FW: composting/biosolids facility built at 1313 Greyback Mountain Road

**Re: Amendment Bylaw No. 2800.24**

**RE:** **Okanagan Valley Zoning Amendment Bylaw No. 2800.24**  
**1313 Greyback Mountain Road — Sublot 8, District Lot 2711, SDYD, Plan 1190**

*Image 6 - watercourse clearly seen traversing through the proposed property (blue polygon), along with a red outline indicating Environmentally Sensitive Areas*

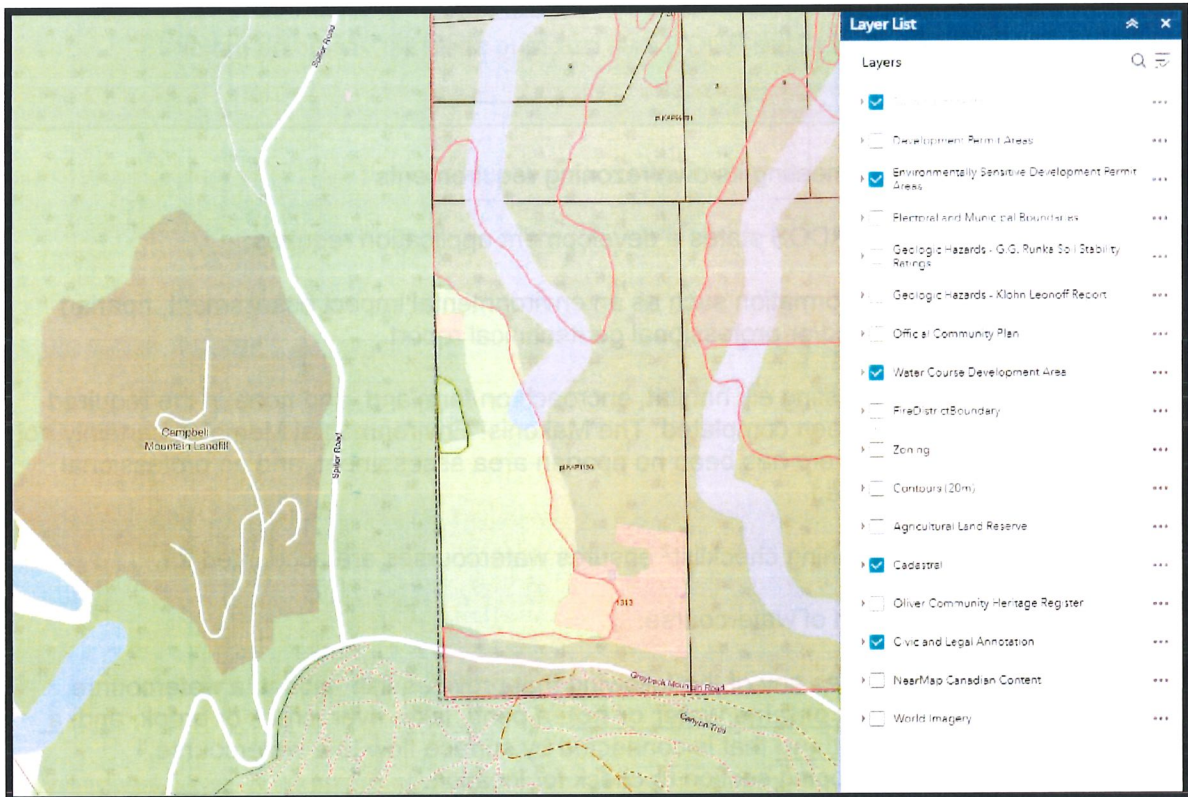
There were no soil samples taken to confirm or disprove the presence of hydric soil indicators to indicate things such as a temporary graminoid marsh.

When asked about this at the RDOS information session the represented dismissed the question despite not being qualified to comment on such matters. He repeated indicated during the presentation and discussion that he was 'only just an Engineer'.

*Image 3: Slide 5 shows a high level map indicating the project area for phase 1 organics compost facility but no indication whatsoever as to what part within the ALR is impact as part of the Biosolids 'Phase 2' work.*

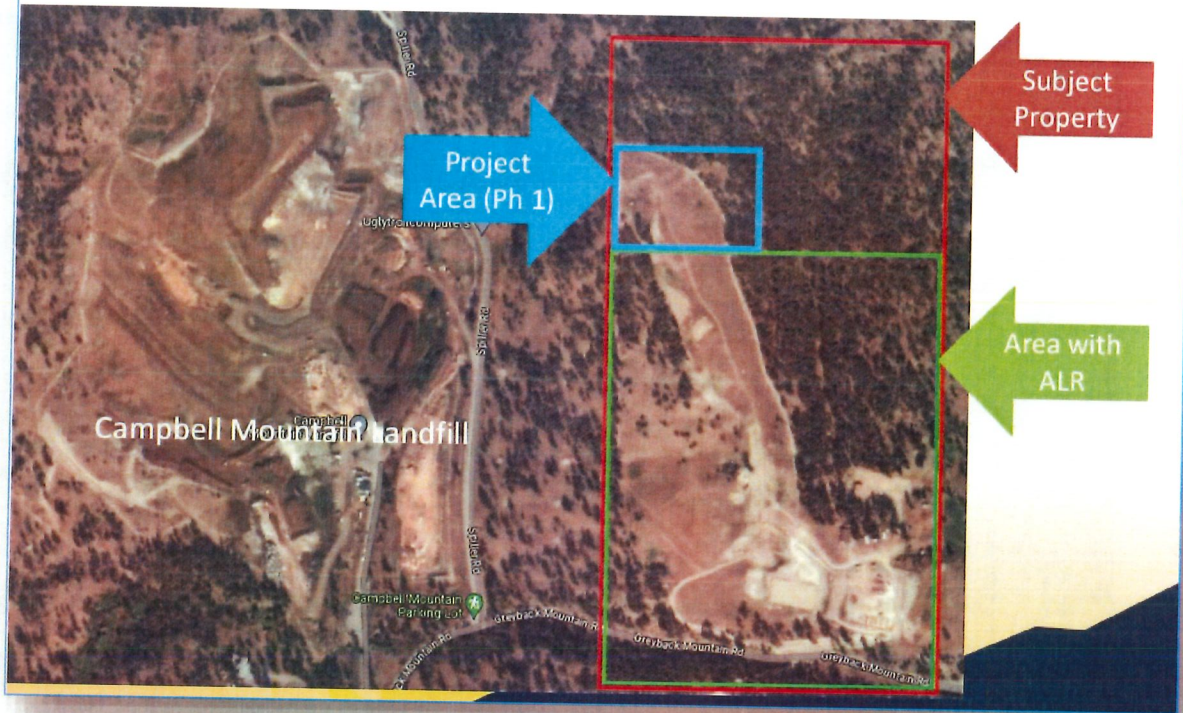
This is misleading and with no mention of Phase 2 or any biosolids facility it almost appears as though ALR land will not be impacted.

*Image 4: Slide 6 shows a conceptual drawing which illustrates composting facility but no layout in regards to the biosolids or "Phase 2" scope.*

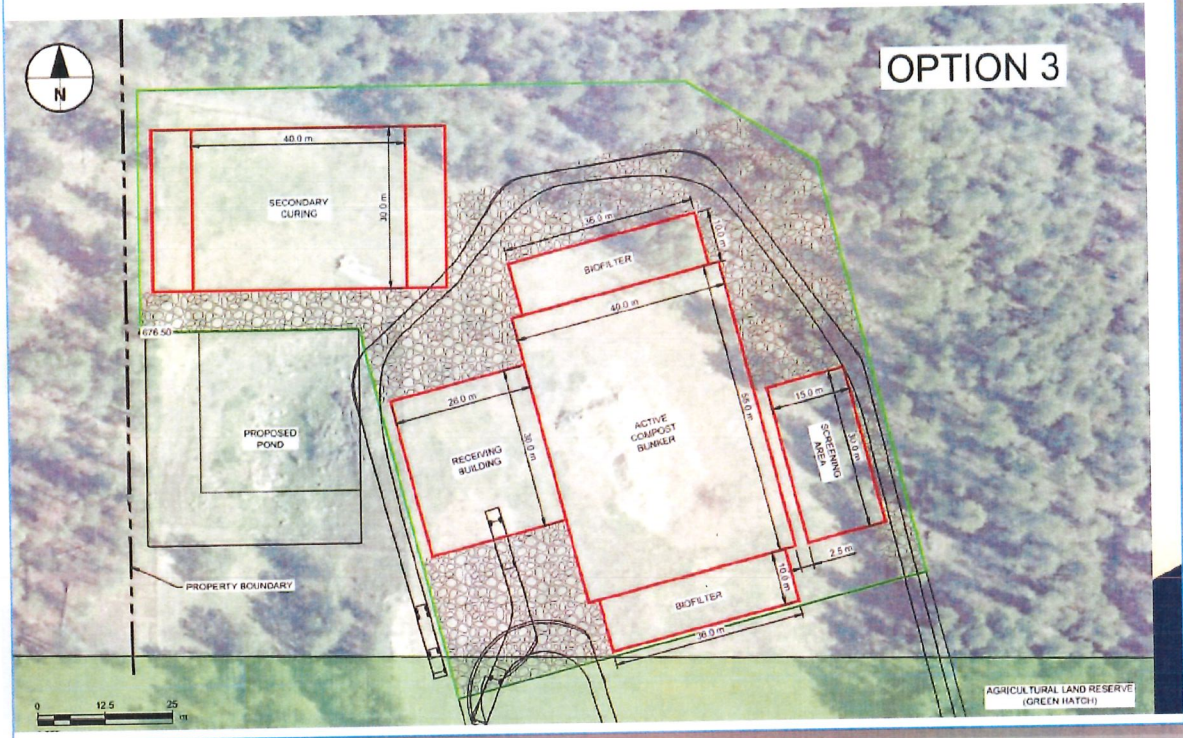
This drawing shows no encroachment to ALR land clearly labeled as the green part at the bottom of the drawing. Presenting only Phase 1 scope not only greatly downplays the scope of the entire facility, but does not allow stakeholders to understand what possible, if any, impacts are to ALR land
